**SECTION 00 9122**  
**REBID ADDENDUM NUMBER 2**

**DATE: December 1, 2016**

**RSMP Phase 2A REBID**  
**James Monroe High School**  
**RFI LOG**  
12/1/16

DRAWING REFERENCE NUMBER(S): AS NOTED  
DRAWING NUMBER: ADD2-S201

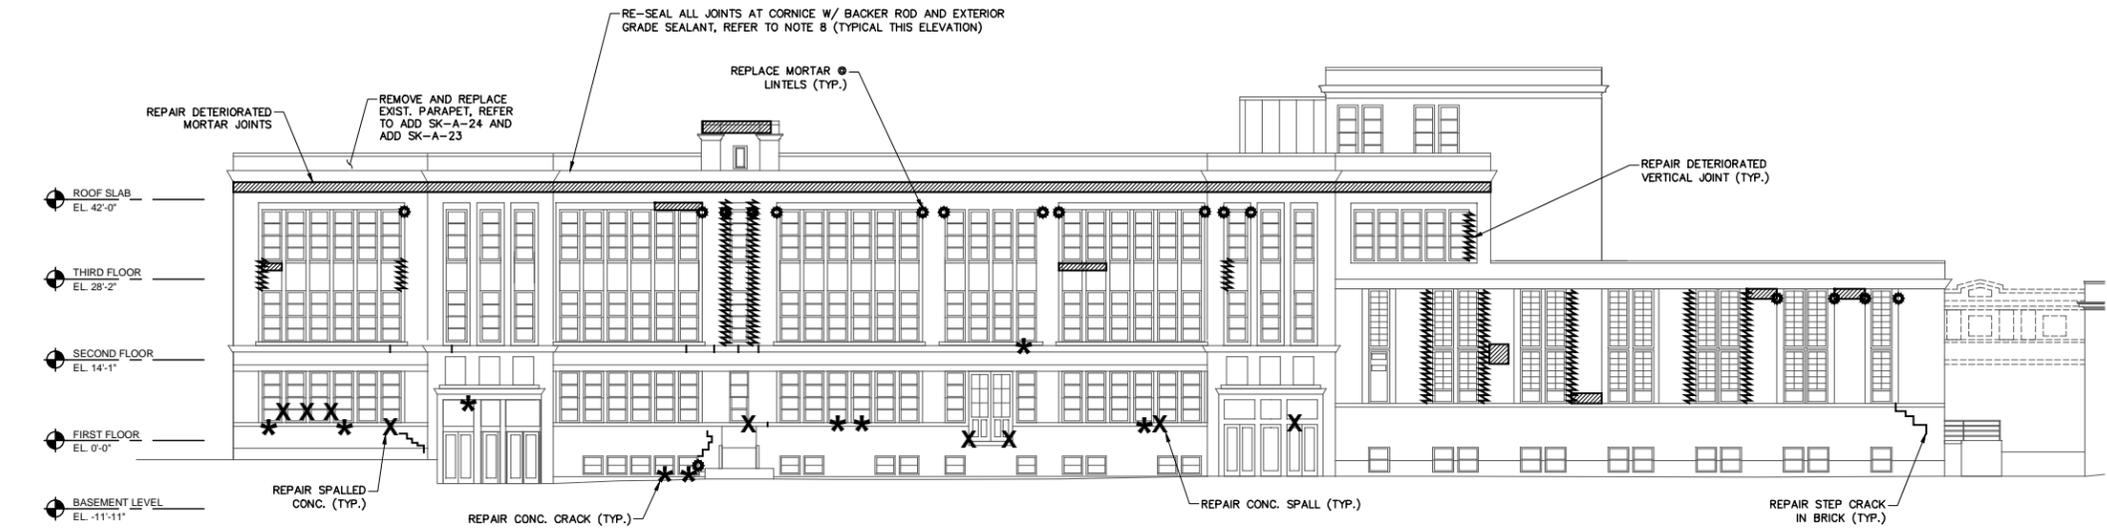
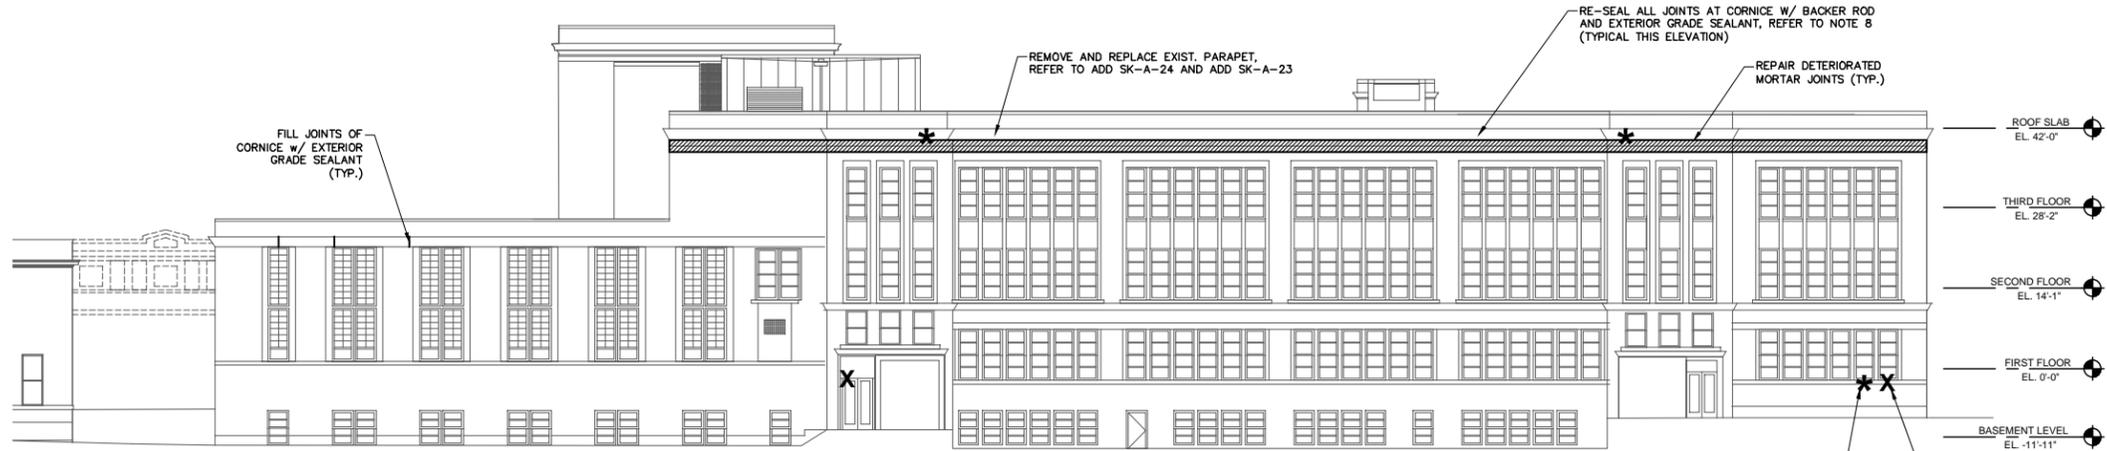
- A. Follow revisions to drawings on the following attached sketches:
- ADD2-SD100 Basement Demolition Key Plan
  - ADD2-S011 First Floor Key Plan
  - ADD2-S013 Third Floor Key Plan
  - ADD2-S200 North and South Façade Elevations
  - ADD2-S201 East and West Façade Elevations
  - ADD2-S311 Enlarged Framing Plans
  - ADD2-S400 Foundation Sections
  - ADD2-S410 Framing Sections
  - ADD2-S501 Typical Details

<b>A120</b>
DRAWING NUMBER: <b>ADDSK-A-23</b>
SED CONTROL NUMBERS: SED. #: 26-16-00-01-0-107-029 DWT #: 26-16-00-01-7-999-019

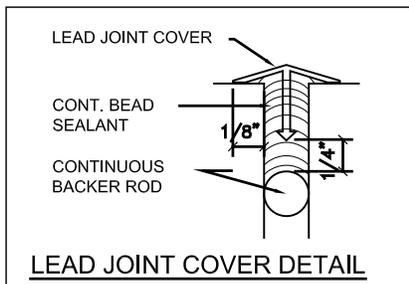
- A. Add sketches ADDSK-A-23 showing parapet wall section. Follow ADDSK-A-24 for locations of parapet work.

NOTE:  
WHEN SALVAGING PARAPET WALL CAPS, CATALOG IN SUCH A WAY AS TO REINSTALL EACH IN THEIR ORIGINAL LOCATION AND ORIENTATION.

REMOVE EXISTING PARAPET WALL CAPS - SALVAGE FOR REINSTALLATION. RESET ON NEW PARAPET WALL.

REMOVE AND REPLACE EXISTING BRICK COURSES WITH NEW MATCHING BRICK, IN KIND. PROVIDE CONT. 9 GA. TRUSS TYPE HORIZ. JOINT REINF. EVERY THIRD COURSE.

REMOVE EXISTING LEAD JOINT COVERS (NOT SHOWN) AT PRECAST CONCRETE CORNICE SECTIONS AND REPOINT JOINTS WITH BACKER ROD AND SEALANT, PRIOR TO COMMENCING NEW WORK.
